PROPOSED SITE PLAN  
EXISTING CONDITIONS

PREPARED FOR  
STEPHEN KRAVITZ  
PLAT 44 LOT 18-4  
104 JOHN DYER ROAD  
LITTLE COMPTON, RHODE ISLAND

PROPOSED SITE PLAN  
 NEW CONSTRUCTION  
 PREPARED FOR  
 STEPHEN KRAVITZ  
 PLAT 44 LOT 18-4  
 104 JOHN DYER ROAD  
 LITTLE COMPTON, RHODE ISLAND  
 SCALE: AS NOTED DATE: APRIL 24, 2023  
 JOB #18-034 SHEET 2 OF 3

**PROPOSED SITE PLAN OWTS/DRAINAGE DETAILS & NOTES**

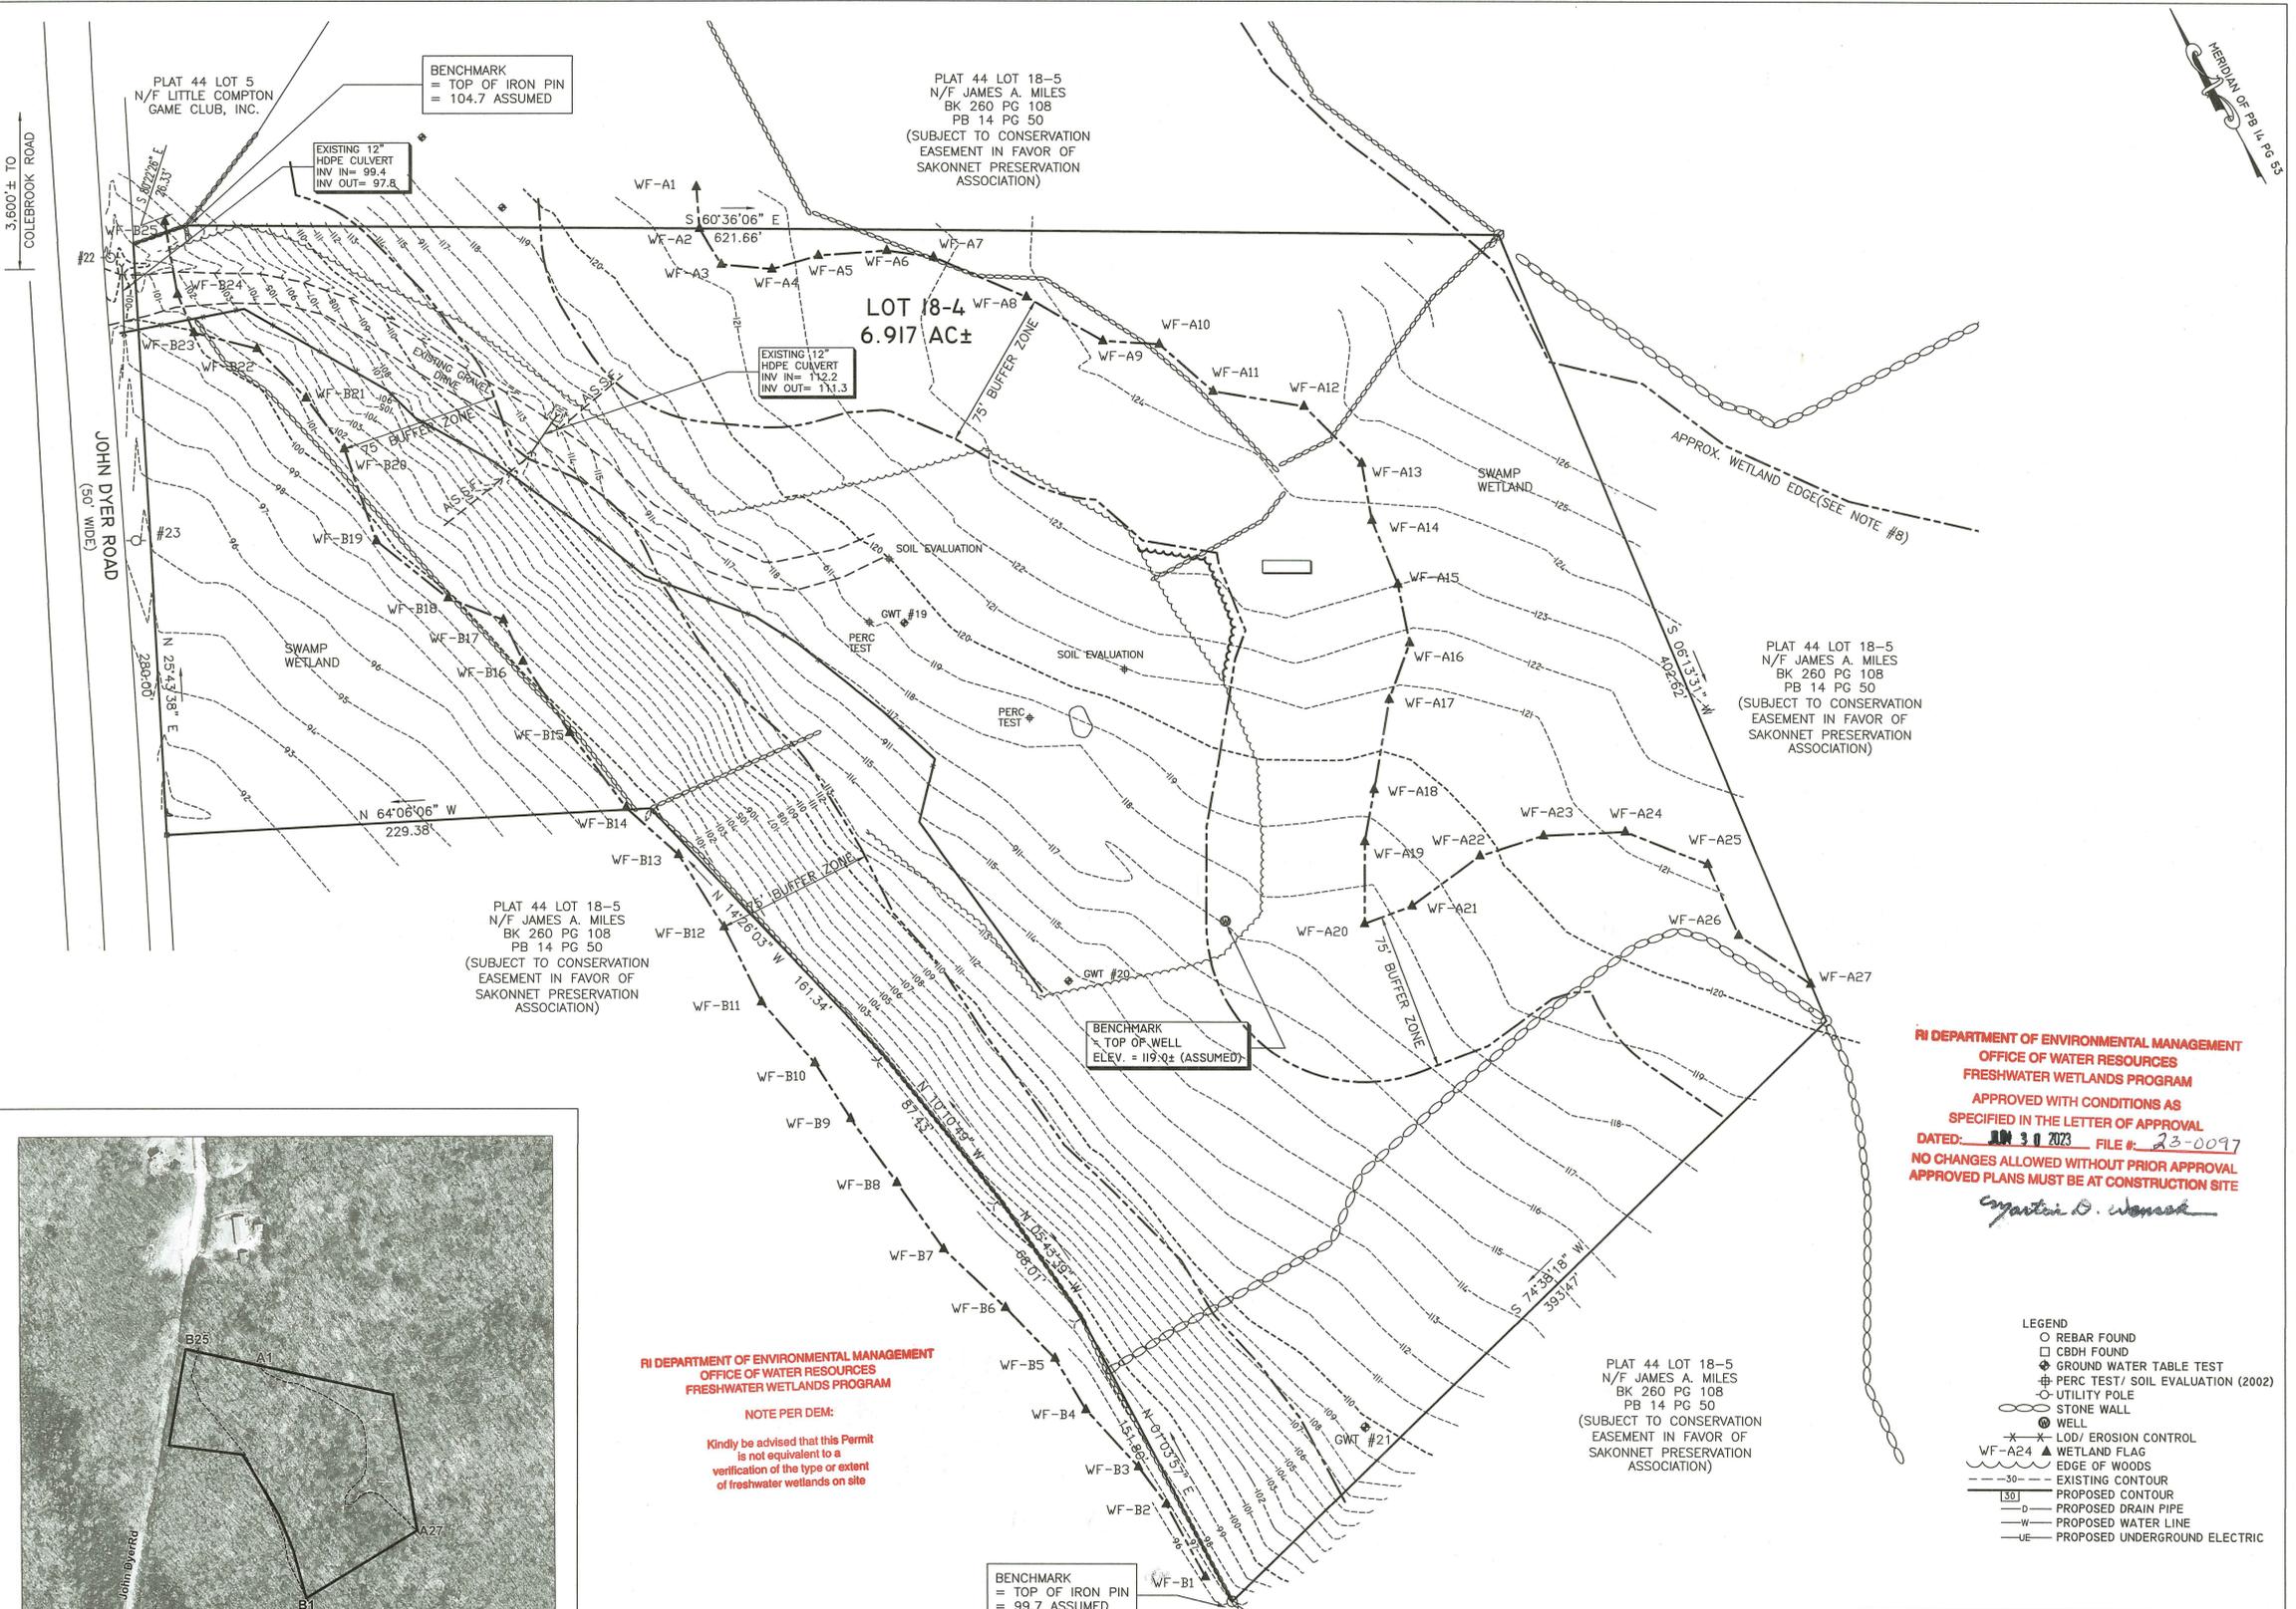
Per RIDEM:  
 The driveway must be constructed of  
 crushed stone, per Condition 11.
